Access Compliance Report

Public Rights-of-Way

(Curb Ramps)

Intersection ID: 6172	Main Street: DOUBLE_SPRINGS_CT	Cross Street: RUMSTONE_LN	Location: S
ADA ID: 88059AE683F5	Ramp Type: Perp	Initial Pass/Fail: Fail	Overall Compliance: No
Severity Score: 8.75			
Codes/Mitigation Info/Possible Solution		Field Measurements/Component Compliance

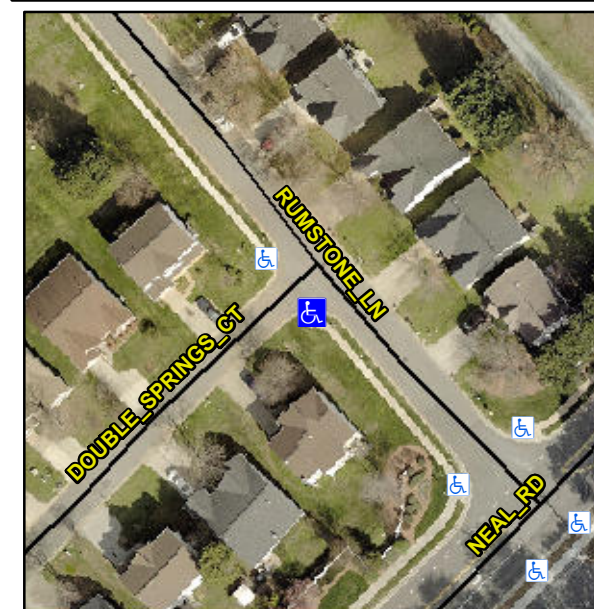
Not Found, R304.5.1

Compliance	Description	Data	Compliance	Description	Data
N/A	Ramp Length (in)	98.0	Yes	Ramp Slope (%)	7.1
No	Ramp Width (in)	46.0	Yes	Ramp XSlope (%)	1.7
N/A	Flare Type LT	N/A	N/A	Flare Type RT	N/A
N/A	Flare Slope LT (%)	N/A	N/A	Flare Slope RT (%)	N/A
N/A	Flare Traversable LT?	N/A	N/A	Flare Traversable RT?	N/A
N/A	Landing Length (in)	N/A	N/A	DWS Provided?	N/A
N/A	Landing Width (in)	N/A	N/A	DWS Contrast?	N/A
N/A	Landing Slope (%)	N/A	N/A	DWS Length (in)	N/A
N/A	Landing X Slope (%)	N/A	N/A	DWS Full Width?	N/A
N/A	Landing Curb? (Y/N)	N/A	N/A	DWS Offset (in)	N/A
N/A	Shared Landing?	N/A			
N/A	Gutter Ponding?	N/A	N/A	Gutter Slope (%)	N/A
N/A	Gutter Lip Ht (in)	1.5	N/A	Gutter X Slope (%)	N/A
N/A	Painted X Walk1?	No	N/A	Painted X Walk2?	N/A
	X Walk 1 Direction	To NW		X Walk 2 Direction	N/A
N/A	X Walk 1 Width (in)	N/A	N/A	X Walk 2 Width (in)	N/A
	X Walk 1 Slope (%)	0.3		X Walk 2 Slope (%)	N/A
	X Walk 1 X Slope (%)	0.9		X Walk 2 X Slope (%)	N/A

Remove & Replace Entire Ramp.
